**MONTGOMERY COUNTY PLANNING DEPARTMENT**  
 THE MARYLAND-NATIONAL CAPITAL PARK AND PLANNING COMMISSION

**Potomac Electric Power Company Darnestown substation: CU-16-04**

**Potomac Electric Power Company (PEPCO) Darnestown Substation: CU-16-04**

**Staff Recommendation:** Approval with conditions

**Figure 5: Landscape Plan**

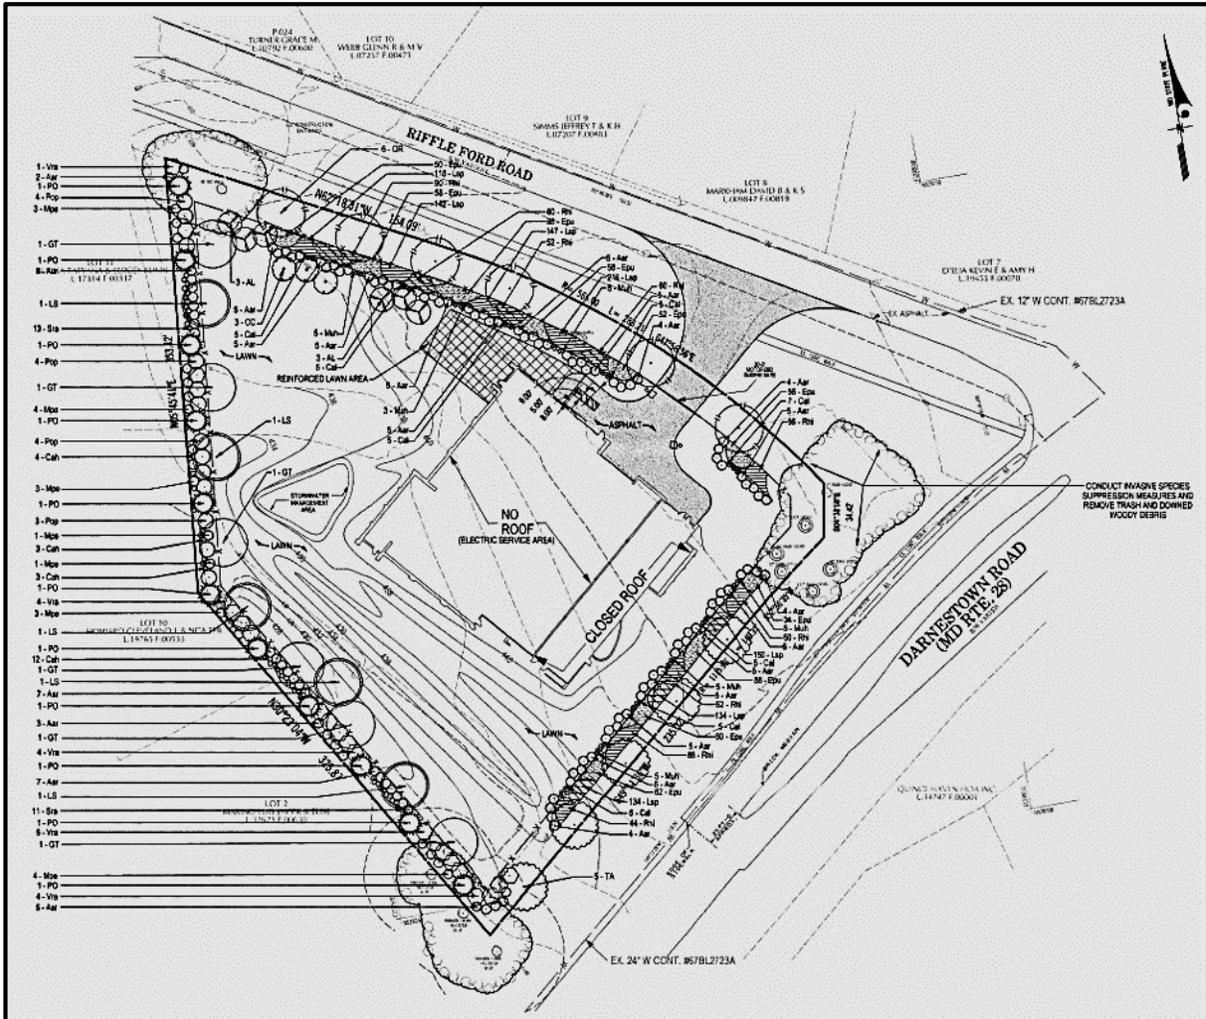
The proposed landscaping with an emphasis on native species is adequate, safe, and efficient. The Landscape Plan achieves the stated objectives in the Zoning Ordinance while providing an attractive appearance throughout the year. It provides screening and buffering between the project and adjacent roads and property. The property is adequately screened and buffered through the use of perimeter landscaping along Riffle Ford and Darnestown Roads with periodic viewsheds onto the property along these roadways for security purposes. The landscaping also is used to screen the 8-foot high security fence surrounding the site. The project site is also screened and buffered along the western property boundary from the adjacent residential

community as required in Division 6.5 of the Montgomery County Zoning Ordinance. The Applicant will substantially meet the tree canopy coverage requirement as well.

1. The Landscape Plan must be revised to reflect enhancement of the wooded area at the corner of Riffle Ford and Darnestown Roads by removing all weedy vegetative overgrowth throughout the area and installing appropriate shrubs and groundcovers.

**Figure 6: Elevations**

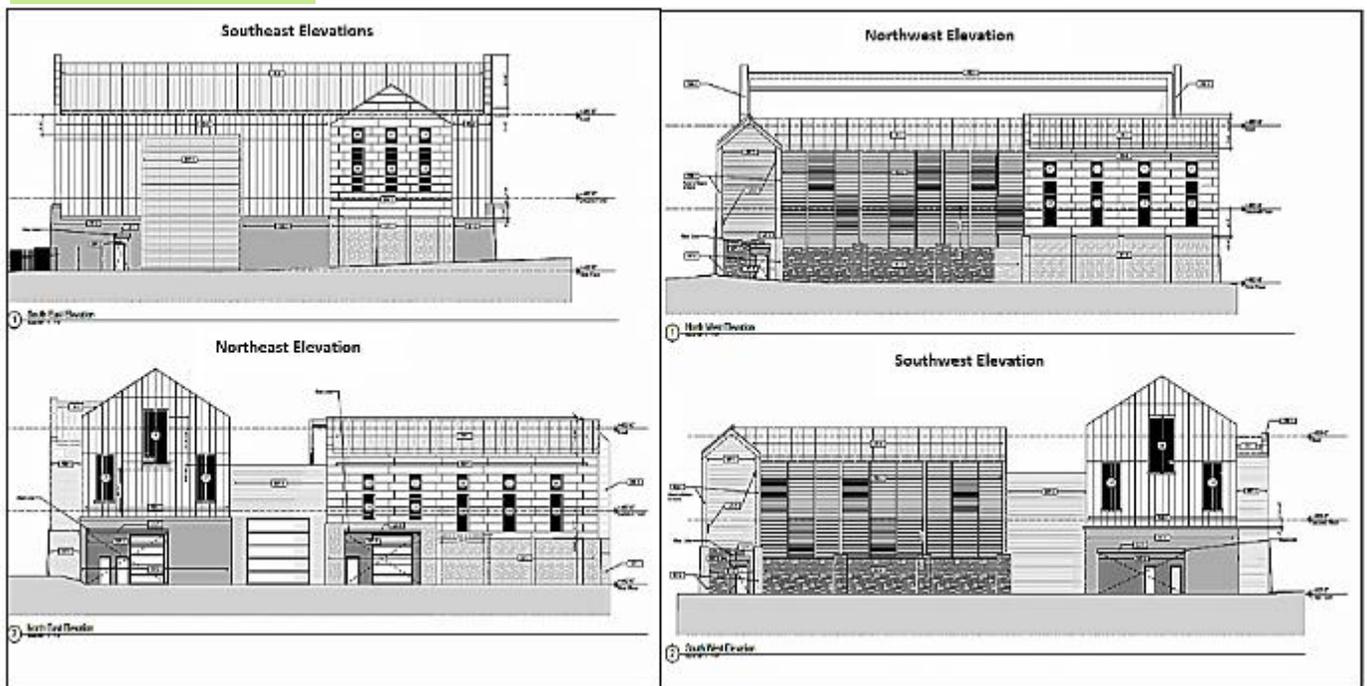
The proposed building is compatible with the surrounding area in terms of its scale, bulk, height, and architectural features. The exterior of the proposed structure is designed to appear as a barn style residence recognizing the Darnestown community's agricultural heritage. The substation is broken into three different masses that allow the structure to appear as a barn that has been expanded over time.

**LIGHTING PLAN**

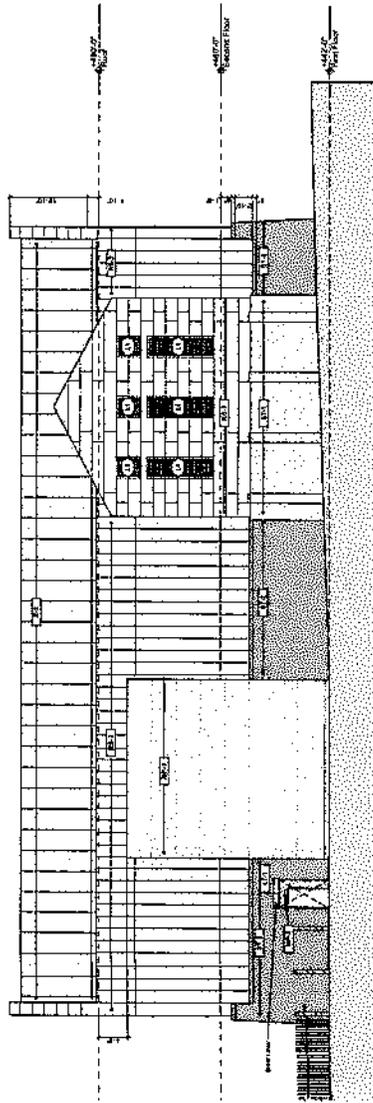
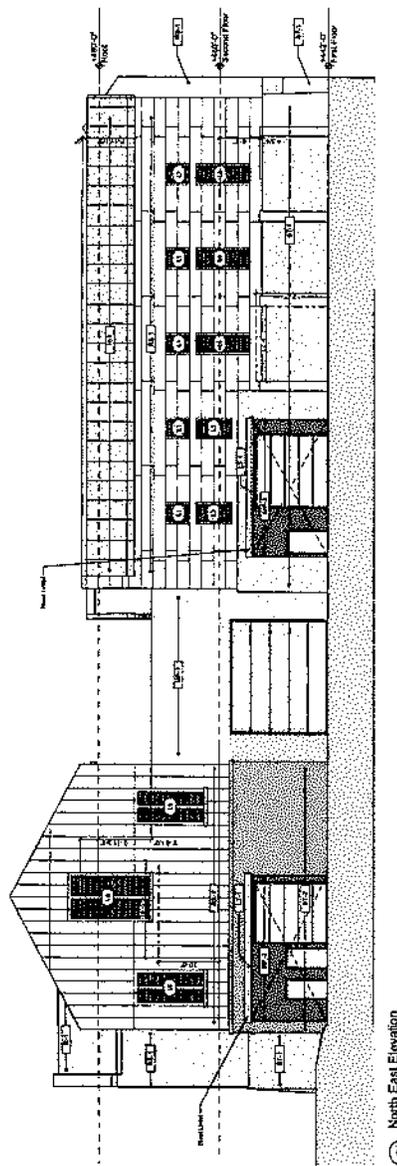
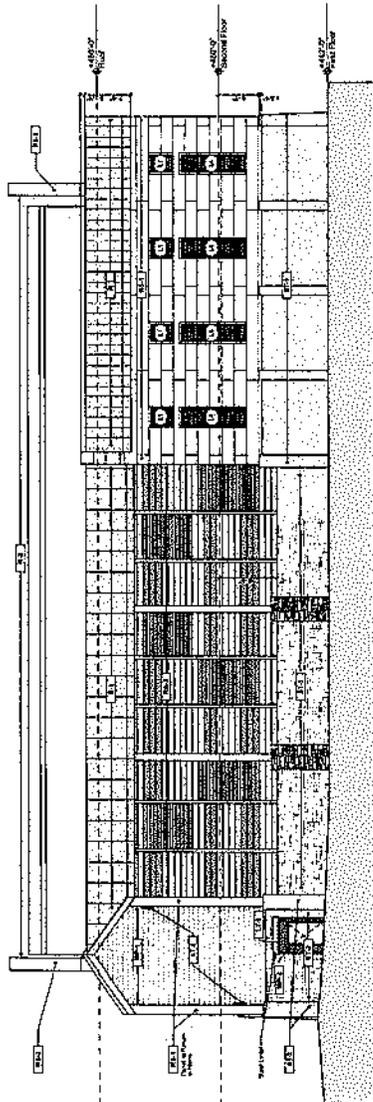
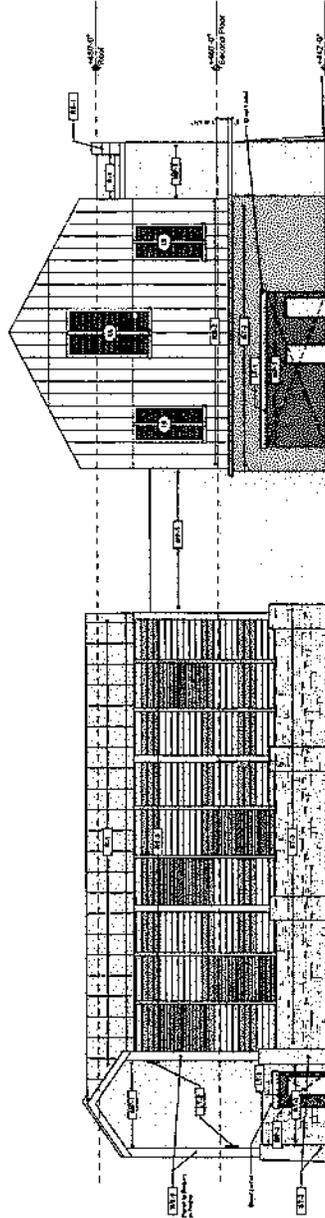
The lighting plan adequately and efficiently provides a safe vehicular and pedestrian environment. The proposed lighting will not cause glare on adjoining properties, nor will it exceed the 0.1 foot-candle standard at the side and rear property lines. A photometric study was submitted with the Application to show that this requirement has been satisfied. In response to staff's comments, the Applicant has revised the lighting plan (Submitted November

23, 2015) to reflect that the lumen grid is extended out further in the driveway and to show where the lumens reaches zero along the drive.
